TRW BUILDING AUC-1
SITE PLAN
LOT 1, BLOCK 1, SHEA CENTER SUBDIVISION FILING NO.1
CITY OF AURORA, COUNTY OF ARAPAHOE, STATE OF COLORADO
A PART OF THE NORTH 1/2 OF SECTION 16, T. 4 S., R. 66 W. OF THE 6TH P.M.

TRW Building AUC-1
ALAMEDA AND RICHFIELD
AURORA, COLORADO
Shea Properties

4 Amendment 4: Update to Perimeter Fence, Entries and revise landscape where necessary.

DRAWN: BILLARLAND
CHECKED: JE
DATE: 10-2-01
SHEET TITLE: LANDSCAPE PLAN

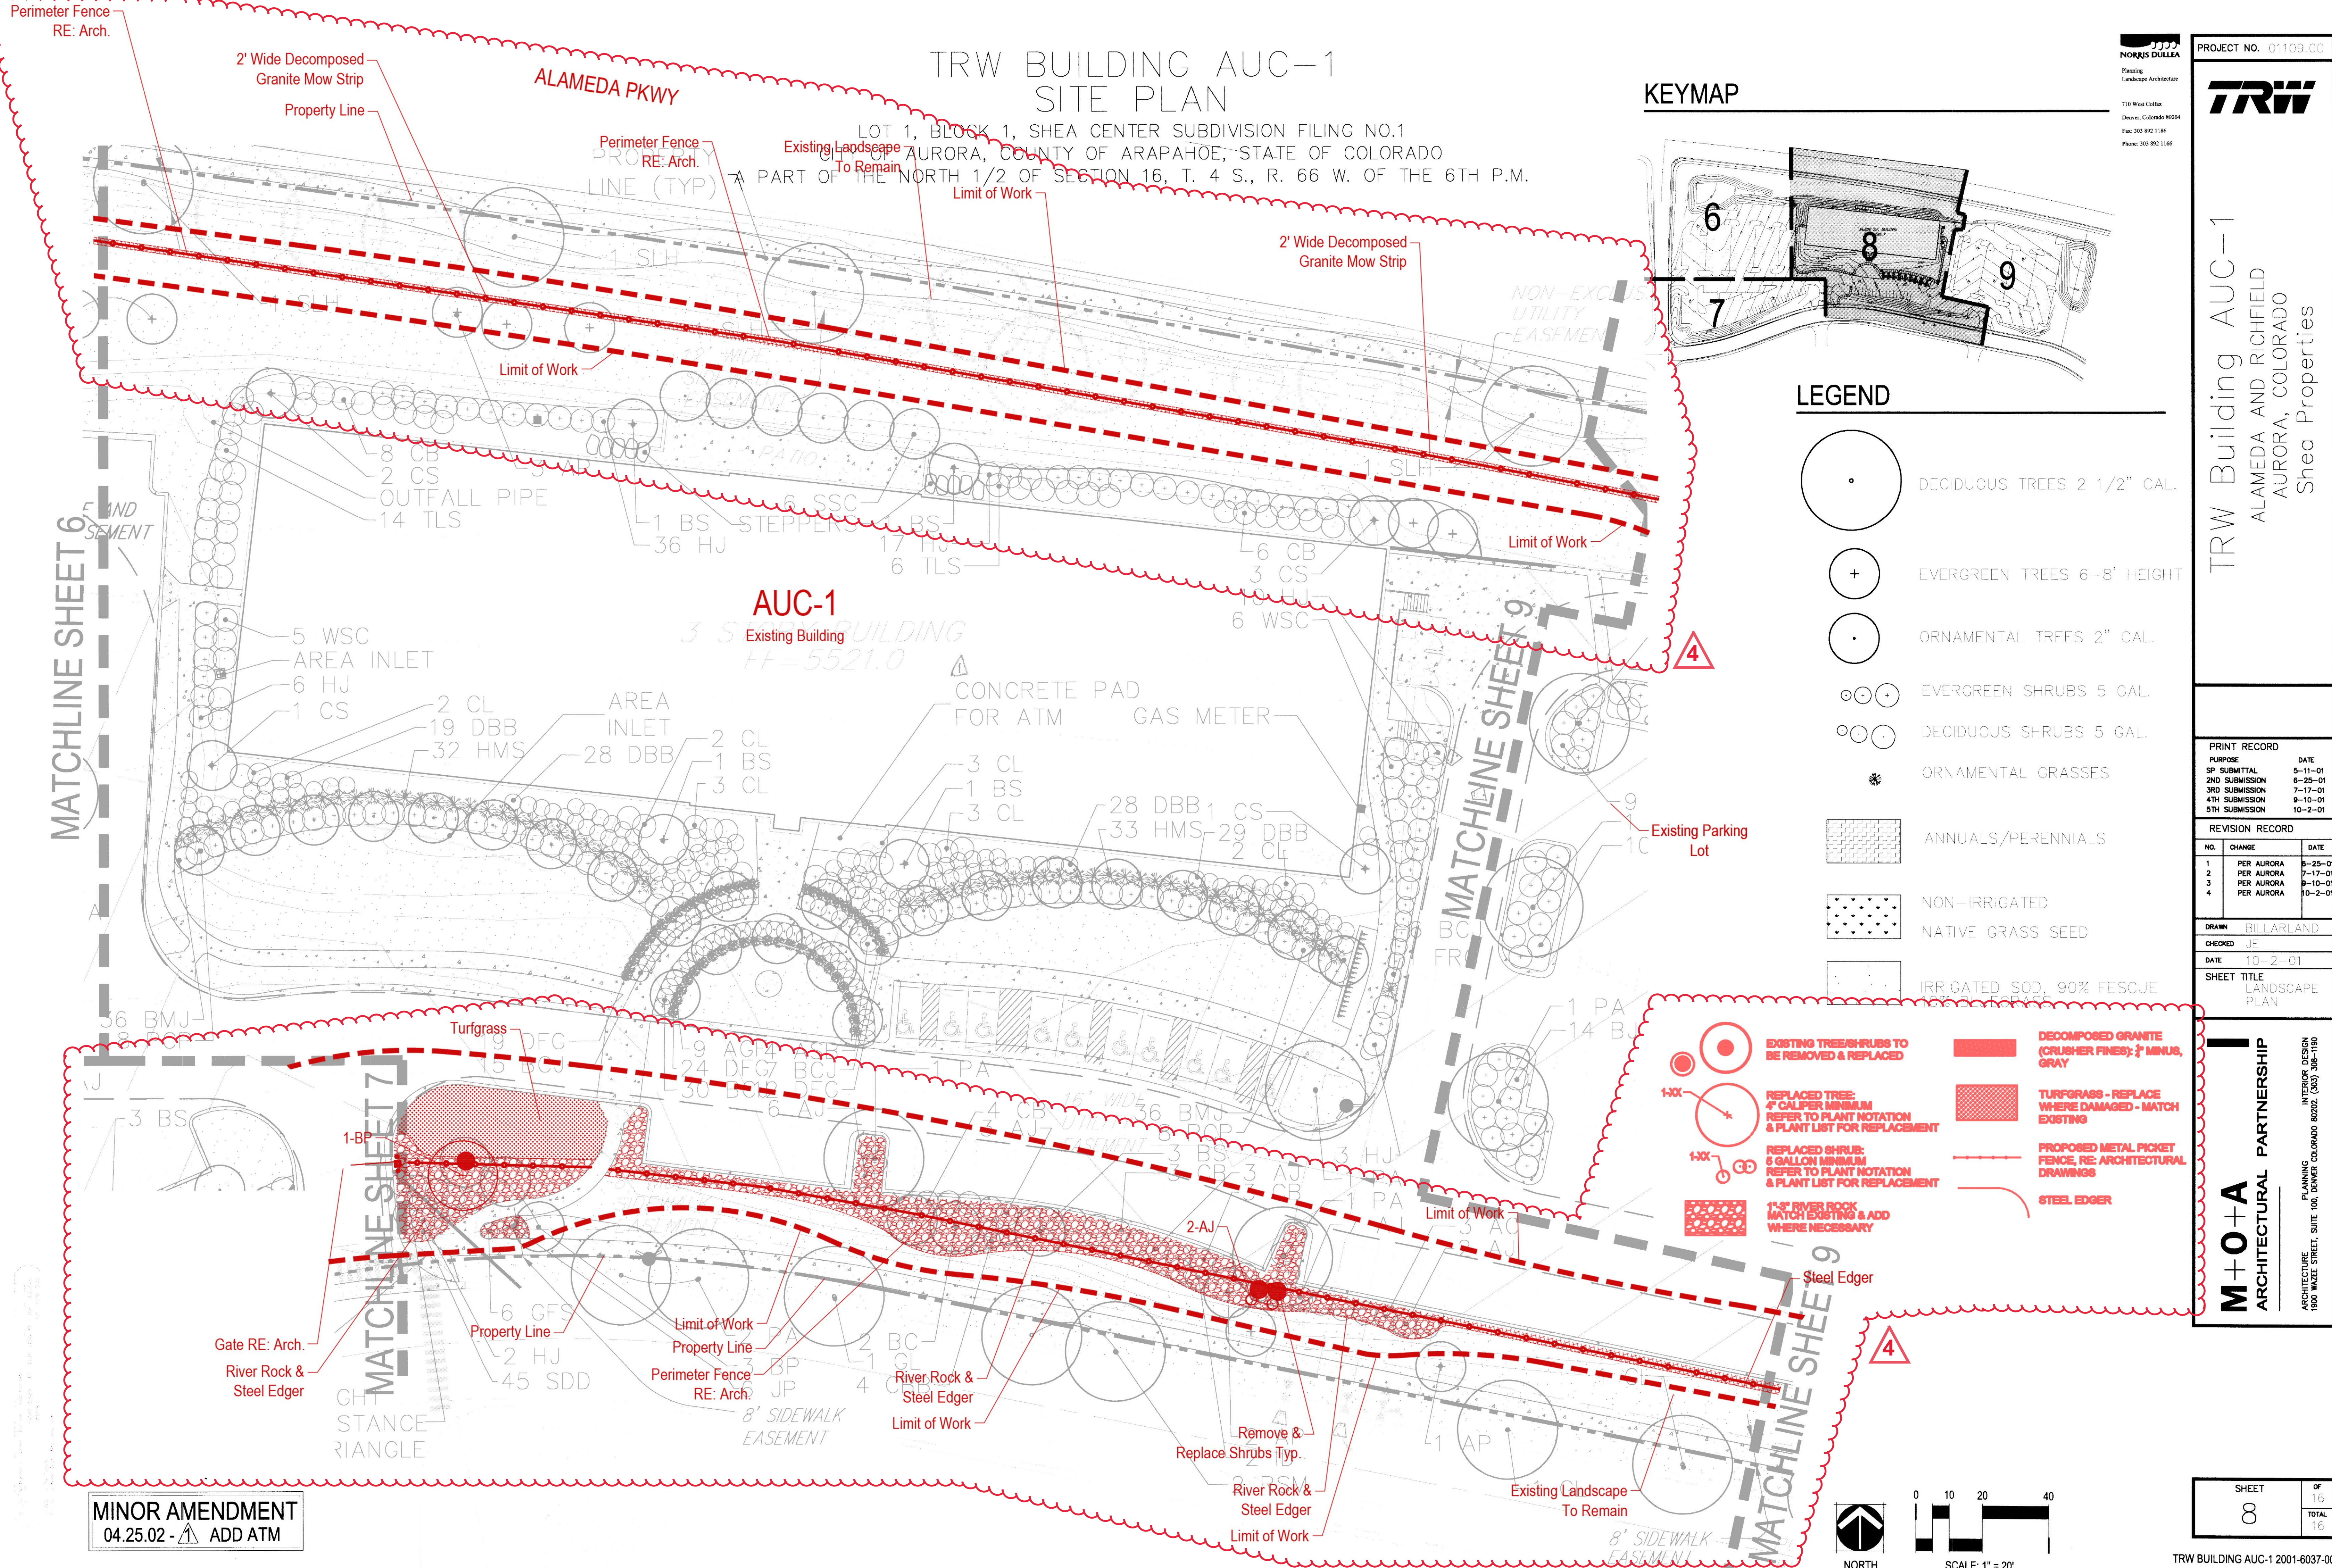
- EXISTING TREE/SHRUBS TO BE REMOVED & REPLACED
- REPLACED TREE: 4" CALIPER MINIMUM REFER TO PLANT NOTATION & PLANT LIST FOR REPLACEMENT
- REPLACED SHRUB: 6 GALLON MINIMUM REFER TO PLANT NOTATION & PLANT LIST FOR REPLACEMENT
- 1" RIVER ROCK MATCH EXISTING & ADD WHERE NECESSARY
- DECOMPOSED GRANITE (CRUSHER FINES) 3/4" MINUS, GRAY
- TURFGRASS - REPLACE WHERE DAMAGED - MATCH EXISTING
- PROPOSED METAL PICKET FENCE, RE: ARCHITECTURAL DRAWINGS
- STEEL EDGER
